Product / Process Change Notification (PCN)							
<input checked="" type="checkbox"/> Major Change <input type="checkbox"/> Minor Change							
PCN Number: PCN_WPME-FDSM_173950375_20250120 Affected Series: WPME-FDSM Affected Part Number: 173950375 PCN Date: 2024-12-20 (YYYY-MM-DD) Effective Date: 2025-01-20 (YYYY-MM-DD)	Change Category: <input checked="" type="checkbox"/> Equipment/Location <input checked="" type="checkbox"/> General Data <input checked="" type="checkbox"/> Material <input type="checkbox"/> Process <input checked="" type="checkbox"/> Product Design <input checked="" type="checkbox"/> Shipping/Packaging <input checked="" type="checkbox"/> Supplier <input type="checkbox"/> Software						
Contact: Product Management Phone: +49 (0) 7942 - 945 5001 Fax: +49 (0) 7942 - 945 5179 E-Mail: pcn.eisos@we-online.com	Datasheet Change: <input checked="" type="checkbox"/> Yes <input type="checkbox"/> No Attachment: <input checked="" type="checkbox"/> Yes <input type="checkbox"/> No						
DESCRIPTION OF CHANGE: <p>Due to an improvement of the production capability, Würth Elektronik eiSos has shifted the production of the affected part number to a new factory location.</p> <p>With

Figure 8: Block diagram.

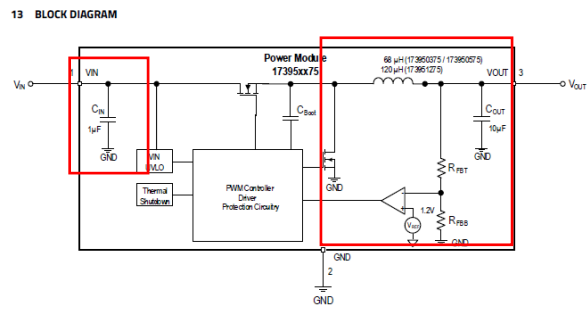
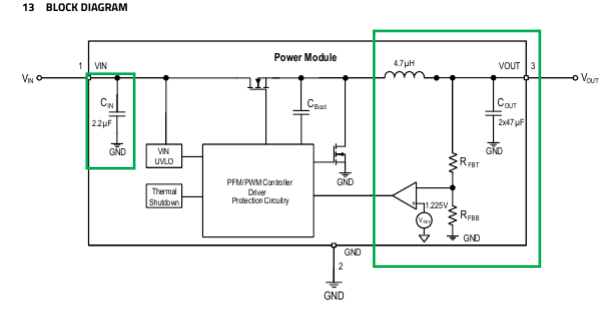
Due to the change of IC and change the internal BOM is changed. The changes in component values and new internal reference voltage are indicated in the BLOCK DIAGRAM chapter.

The V_{OUT} of the regulator is divided by the internal feedback resistor network and fed into the error amplifier, which compares this signal with the internal 1.225V reference. The error amplifier controls the on-time of a fixed frequency pulse width generator, which drives the MOSFET.

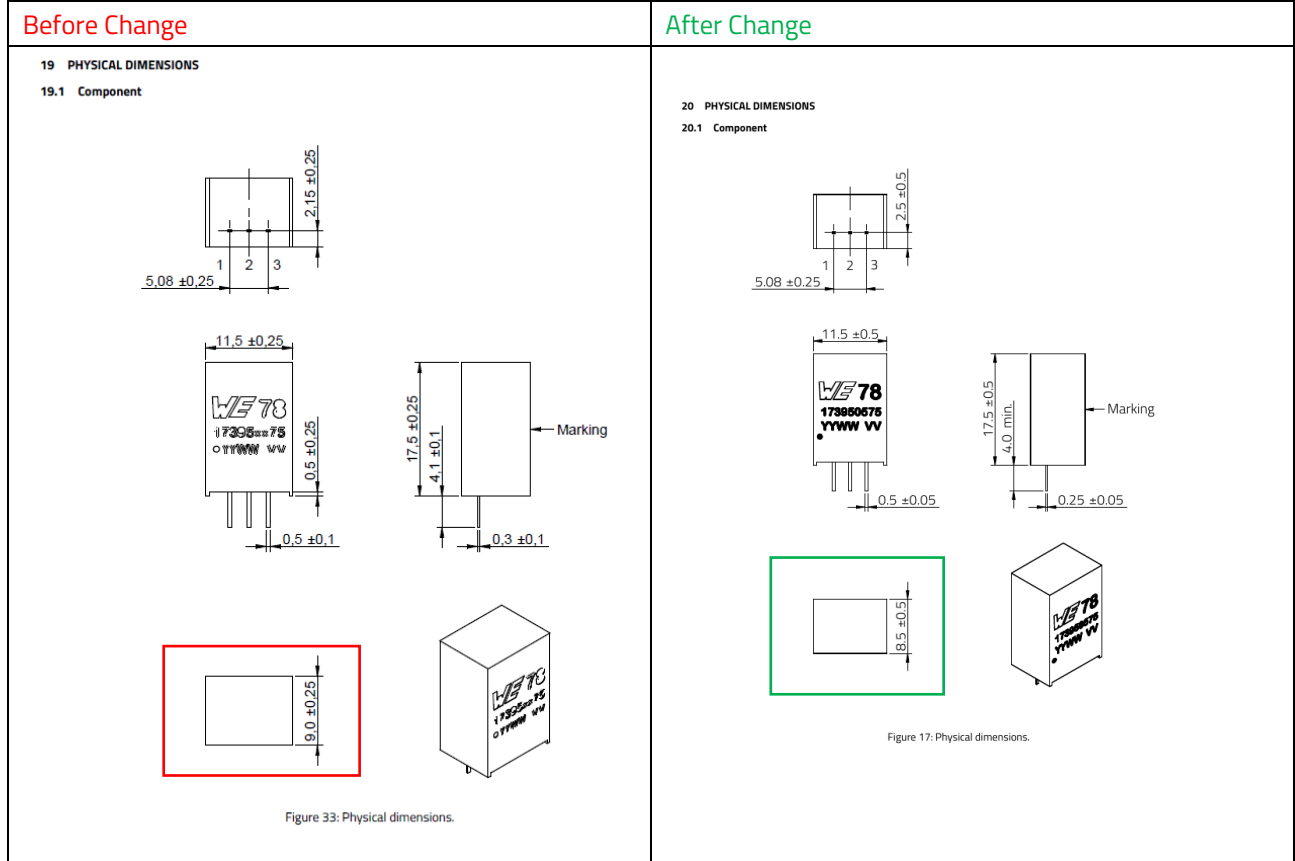
The mechanical dimensions have been updated based on new production. The SIP-3 package shape stays the same but with slightly deviated package width and adjusted tolerances.

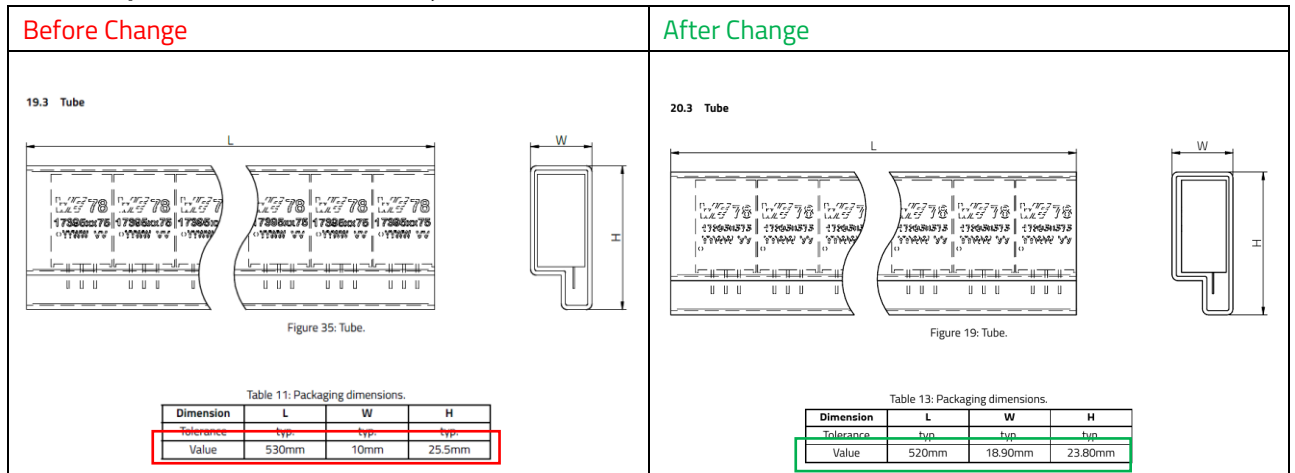
The tube specifications have been adjusted.
